# MEMORANDUM

To: Salt Lake City Planning Commission  
From: Laura Bandara, Urban Designer  
Date: March 23, 2022  
Re: PLNPCM2021-00822 and PLNPCM2021-00835 Pacific Yard

## Planned Development and Design Review (Continued Item)

**ACTION REQUIRED:** Consider modifications made to the proposal in response to discussion and comments made at the February 23, 2022, Planning Commission meeting, and make a final decision on the proposal.

*Rendering of proposed park strip landscaping on 700 South facade. Note that overhead utility line on 700 South will remain.*

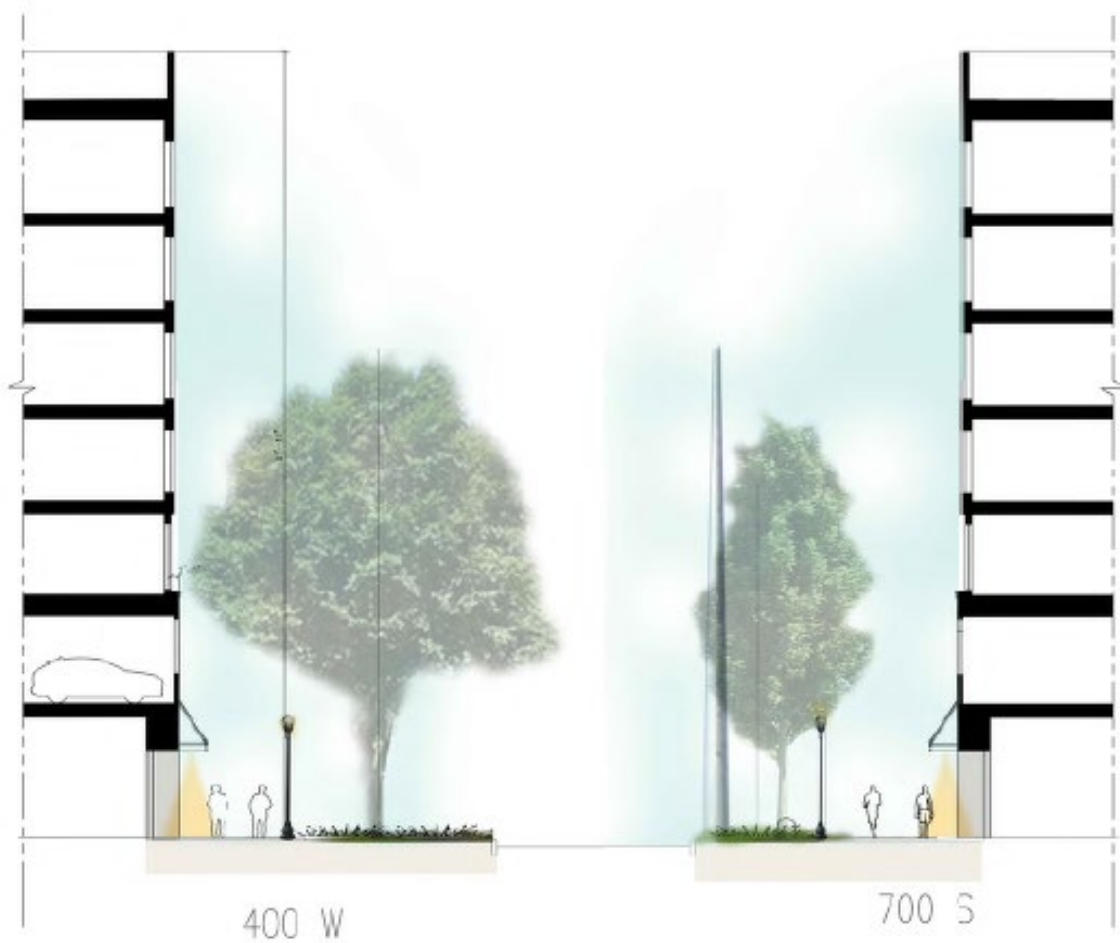
While the proposed park strip landscape is limited in its ability to lessen impacts of the 700 South façade it can provide greenery and create a sense of human scale. As stated above, the applicant is burying the power lines along 400 West but leaving the power lines along 700 South. This limits the height for proposed street trees. With this issue in mind and attempting to create a human scale space on the sidewalk, staff is recommending a condition of approval for a tree form with a spreading canopy in the park strip, that will also meet the needs of the Urban Forestry Division and relevant utility companies.

3. Final approval a tree form with a spreading canopy in the park strip, that will also meet the needs of the Urban Forestry Division and relevant utility companies to be delegated to Planning Staff.
4. A public easement will be recorded on the property for the midblock walkway. A sign will be posted on the midblock walkway stating it is open to the public.
5. A complete lot consolidation application for the three existing parcels shall be submitted and approved.

FIRST FLOOR PLAN

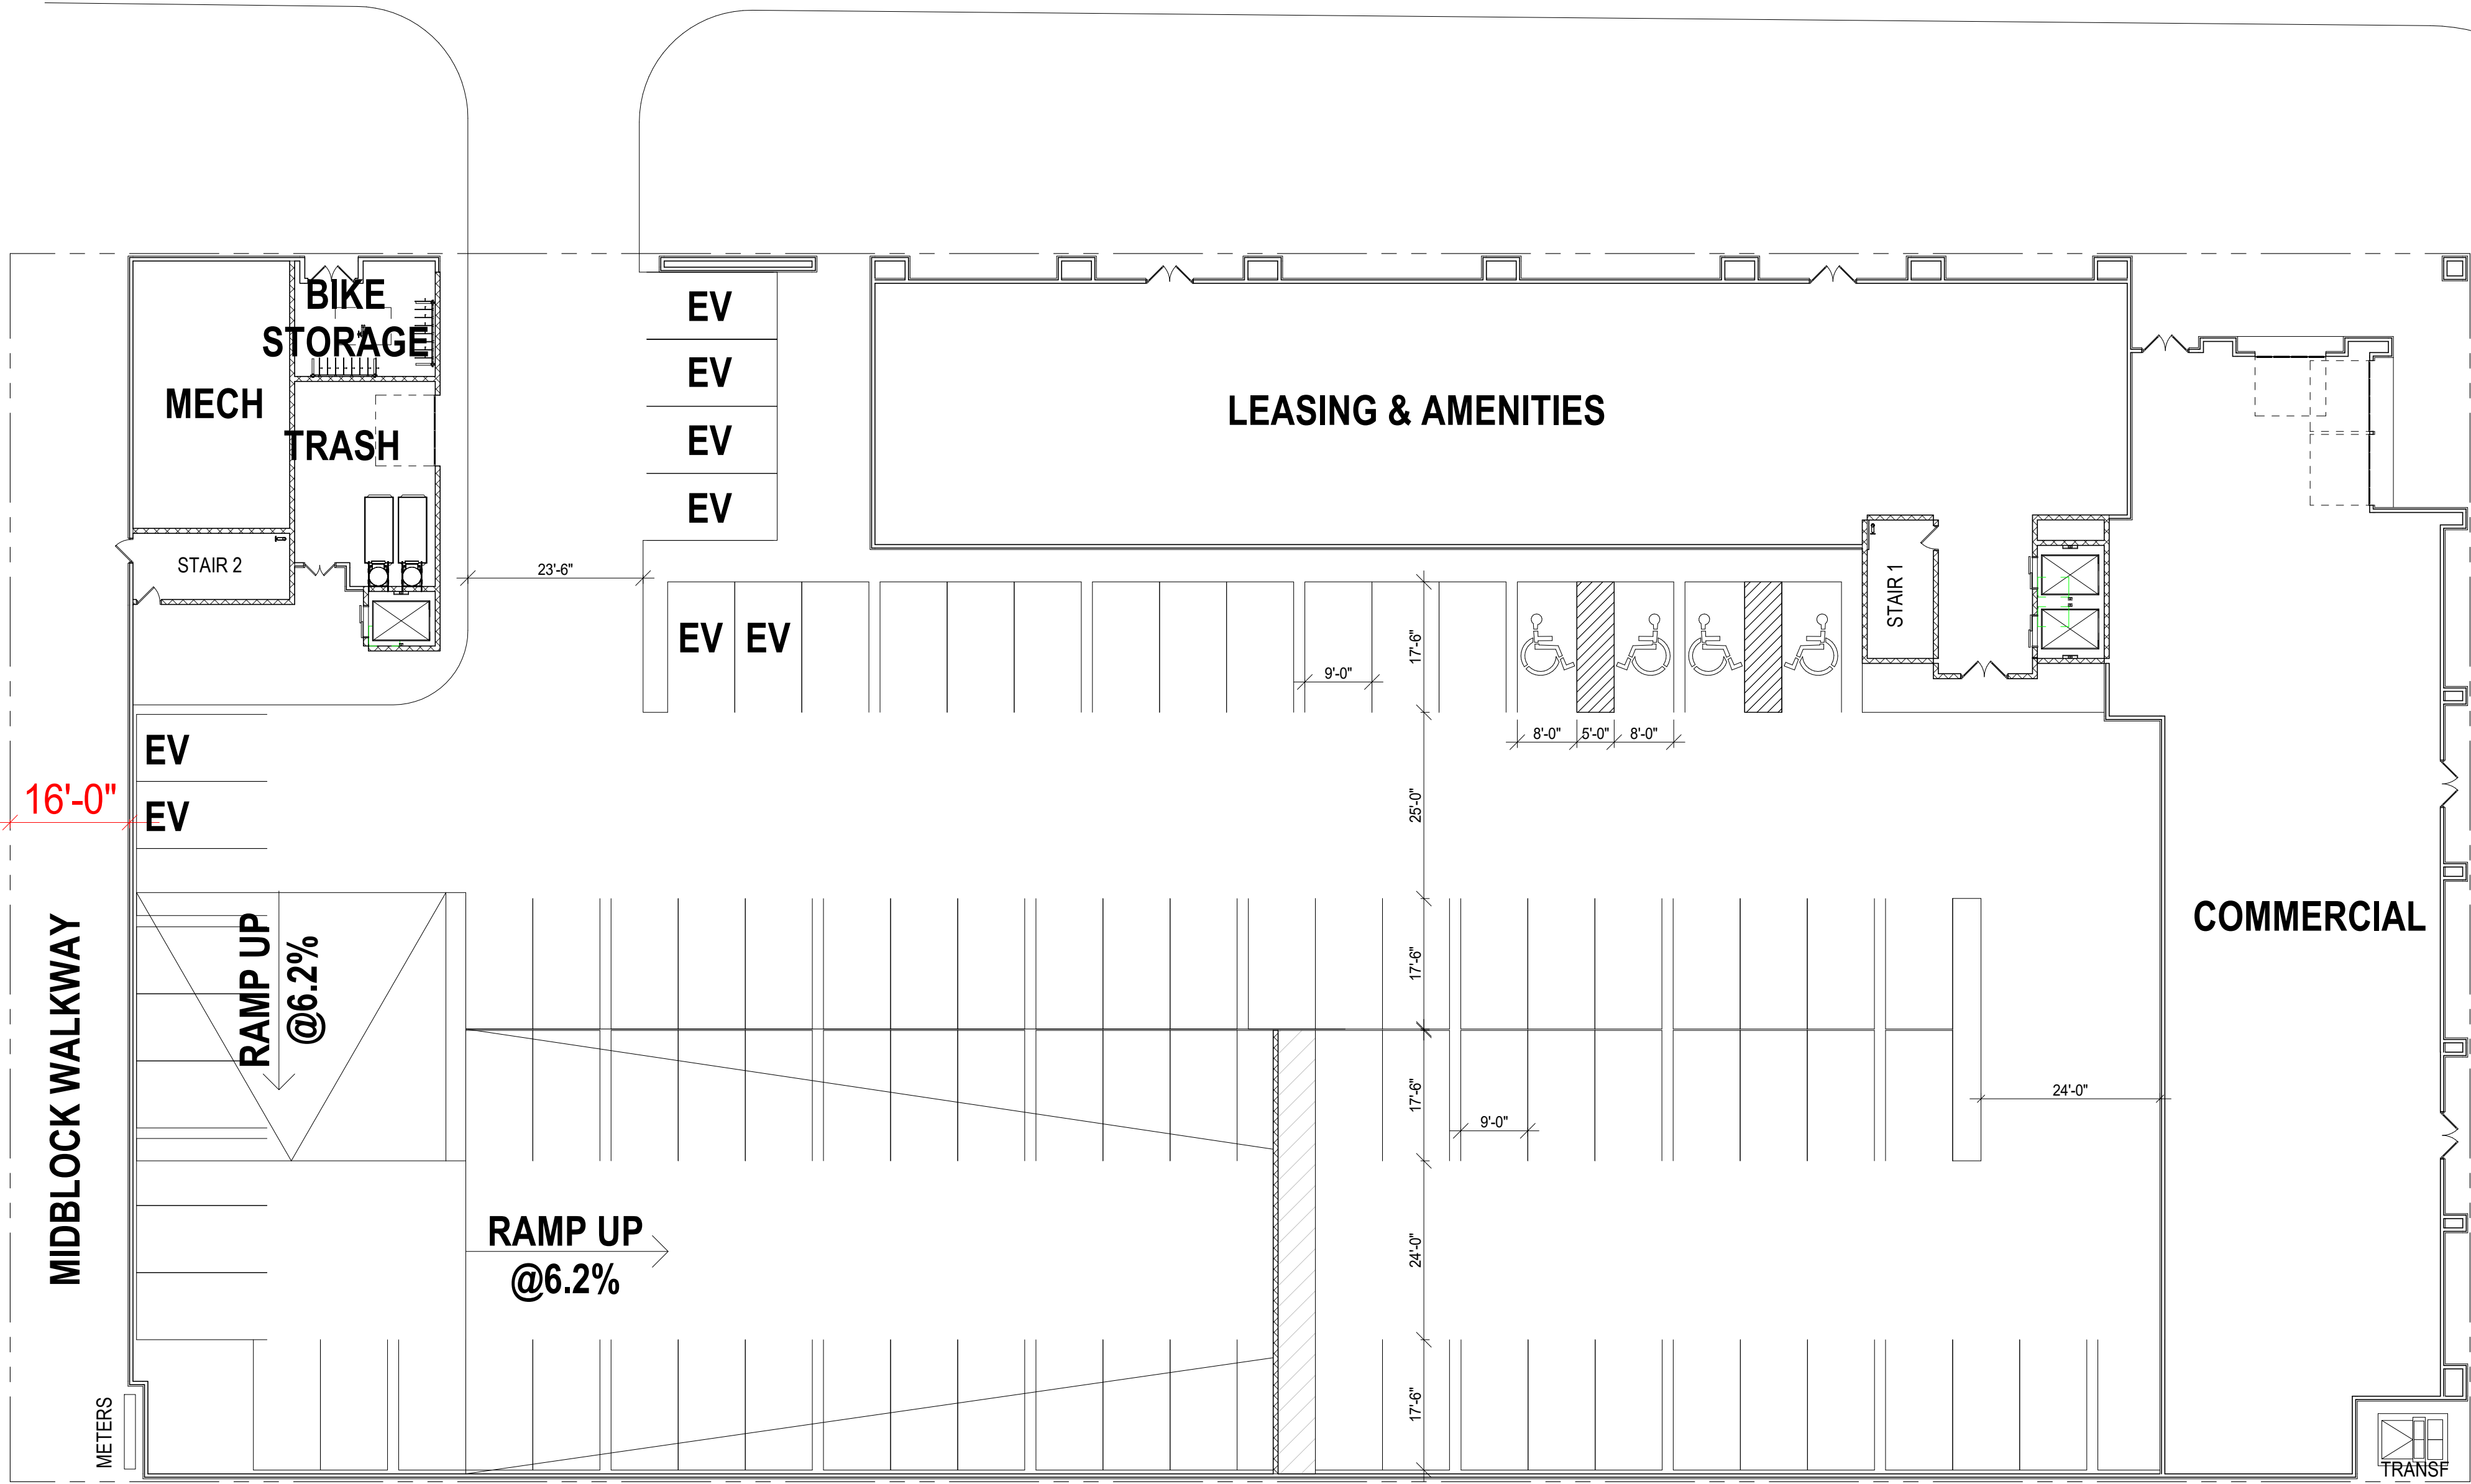
The parking calculations on sheet 9 of 18, "A-01 First Floor Plan", of "2021-1029\_704 S 400 W-Design Review Drawings (24x36)" show the minimum parking required as 215 parking spaces and the parking provided as 208 parking spaces. The applicant should check/verify the parking calculations.
